APPLICATION NO.	FILING DATE	FIRST NAMED INVENTOR	ATTORNEY DOCKET NO.	CONFIRMATION NO.
10/821,737	04/09/2004	Jochen Schweinbenz	10191/3610	1521
26646 7590 09/02/2009 KENYON & KENYON LLP ONE BROADWAY NEW YORK, NY 10004				
EXAMINER				
PAPE, ZACHARY				
ART UNIT		PAPER NUMBER		
2835				
MAIL DATE		DELIVERY MODE		
09/02/2009		PAPER

Office Action Summary

DETAILED ACTION

Fig 1

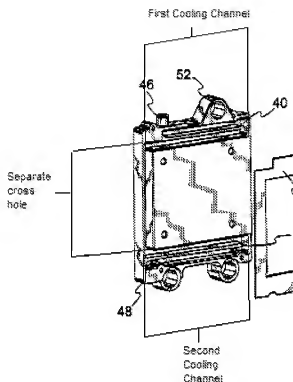
(See Present Office Action Fig 1 below where the first cooling channel, and the second cooling channel, form a plurality of one-piece cooling ducts).

With respect to claim 10, Clamp et al. further illustrates that the one-piece cooling tubes are connected by at least one separate cross hole (Running along the left side of the bottom as illustrated in Fig 2 and present office action Fig 1 below).
